PROJECT TITLE:
 DEHDASHT PETROCHEMICAL INDUSTRY COMPANY
 DEHDASHT HIGH DENSITY POLYETHYLENE PROJECT

DRAWING TITLE:
 PIPING AND INSTRUMENT DIAGRAM (P&ID)

DOCUMENT No:
 DPIC9812-000-VD-1002-ME-PID-0010

PAGE NO. 611B-2

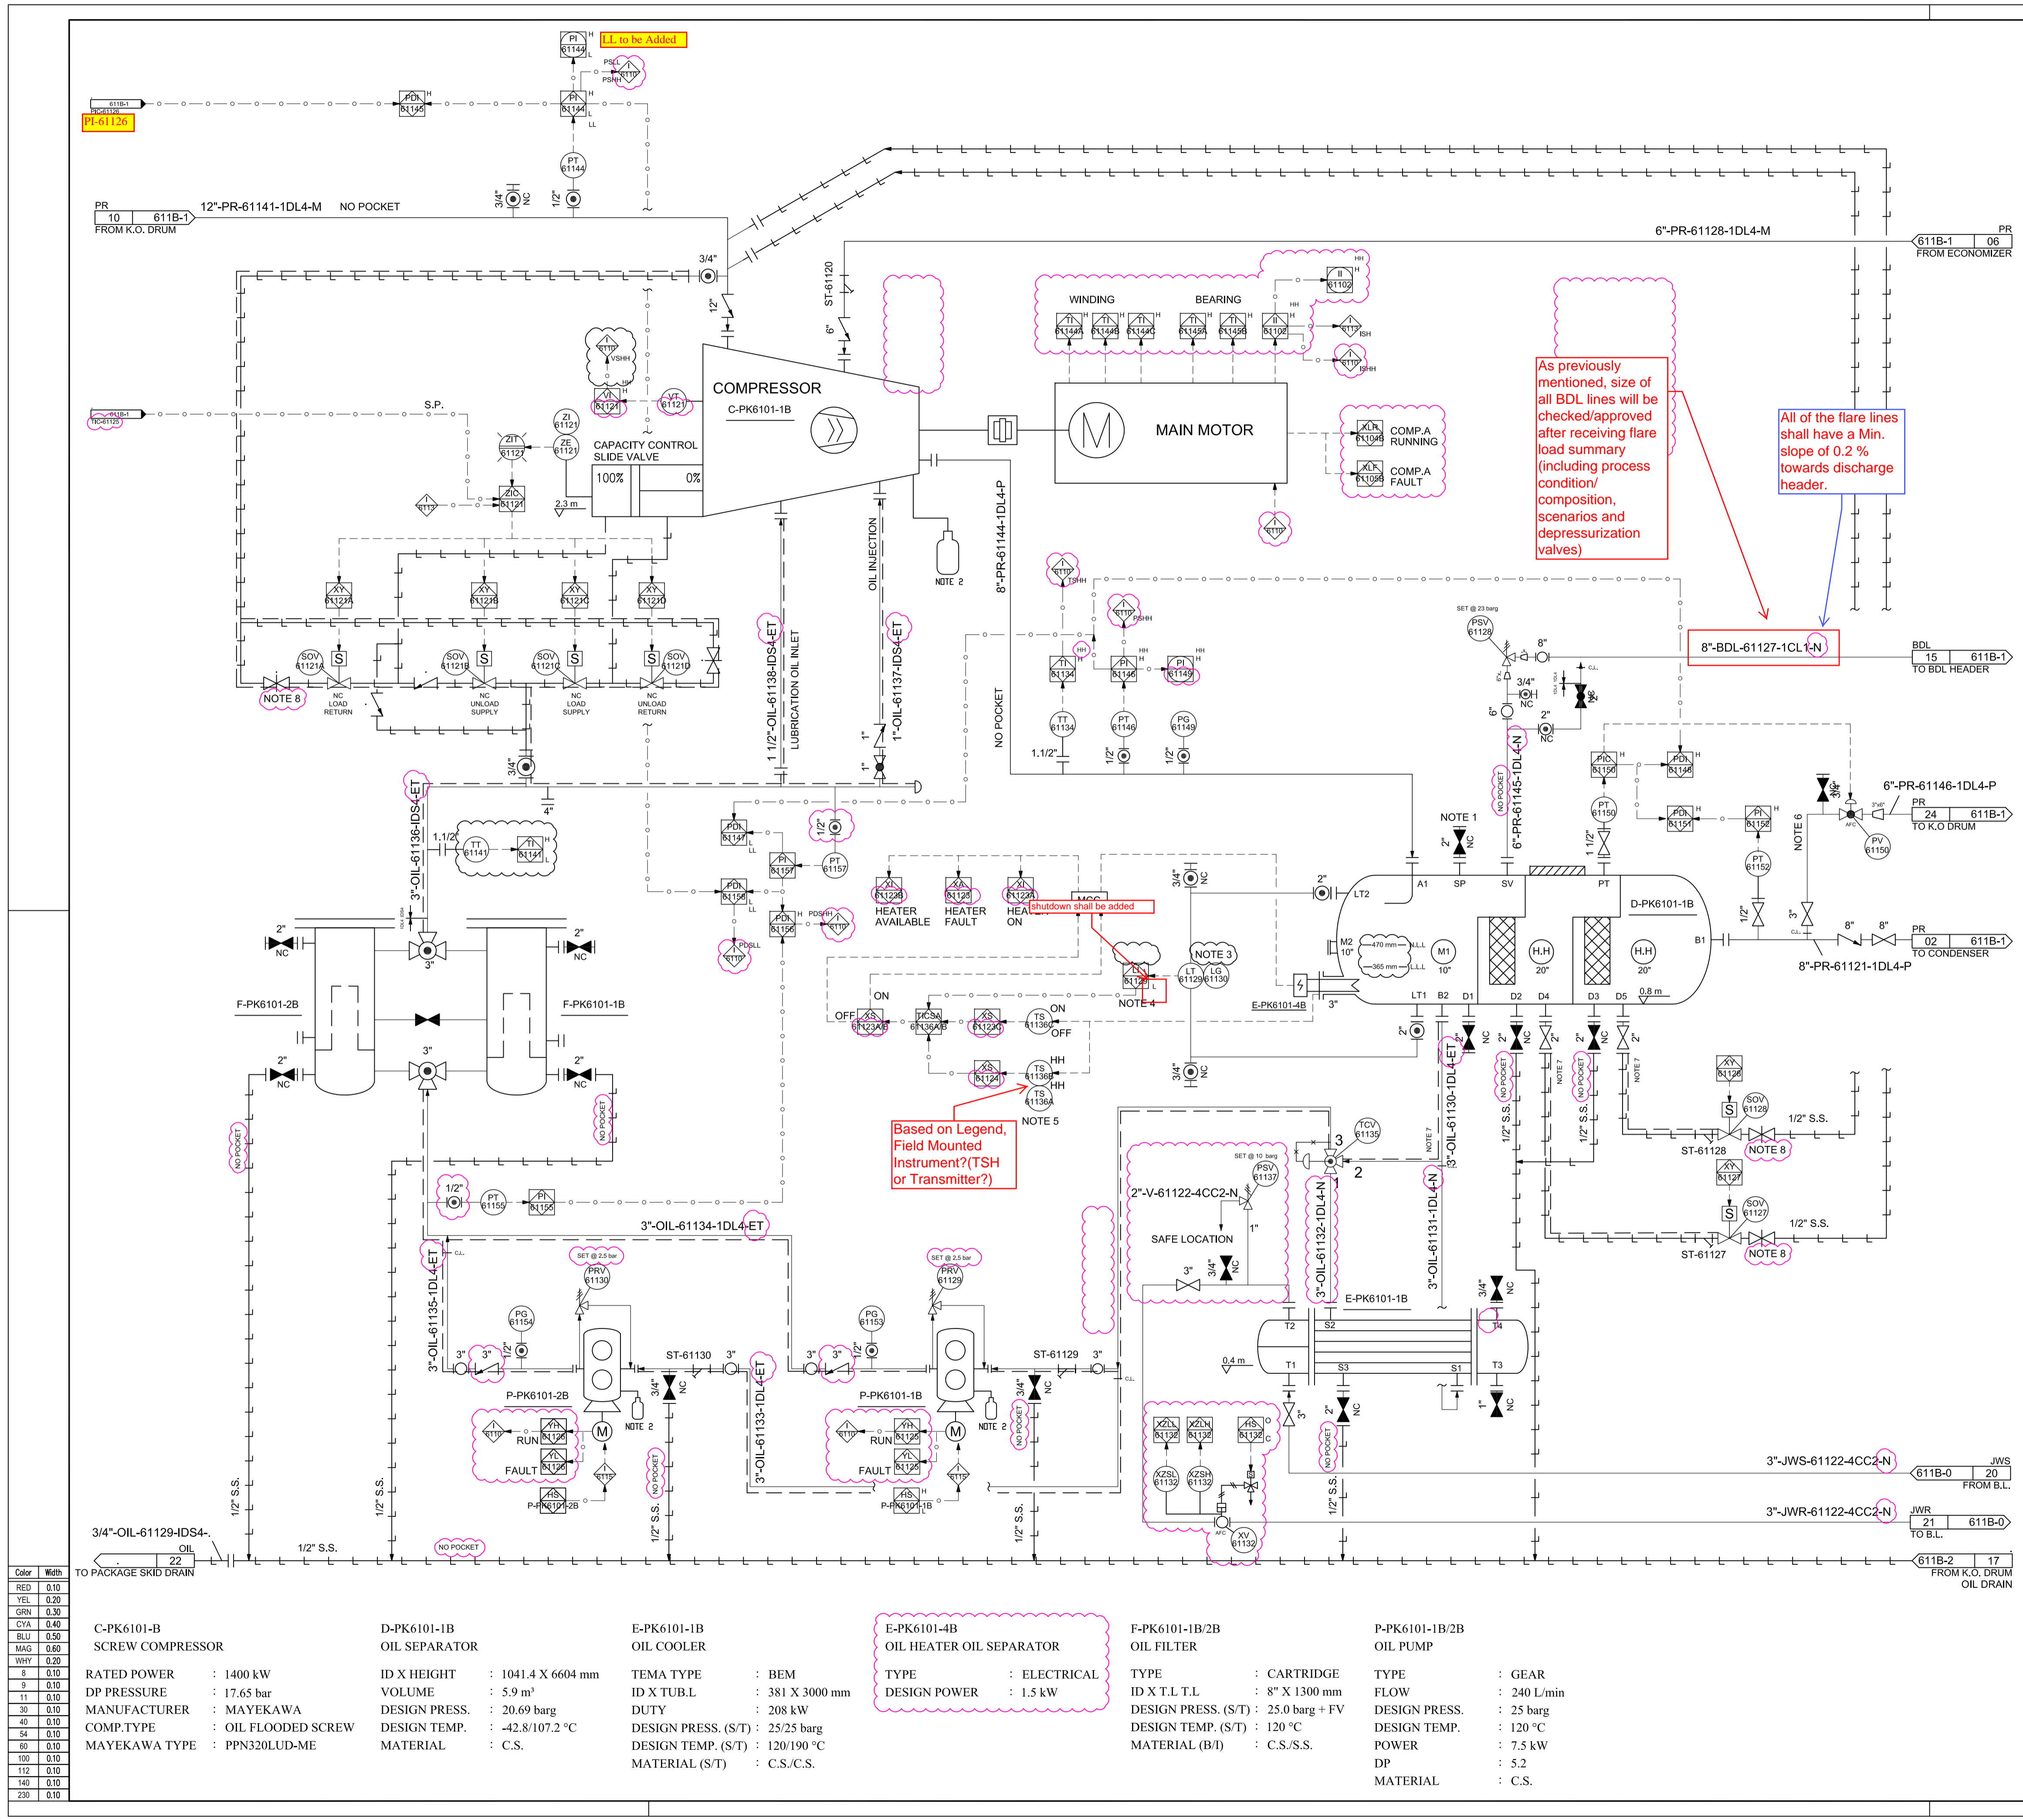
All comments on previous sheet are applicable for this sheet
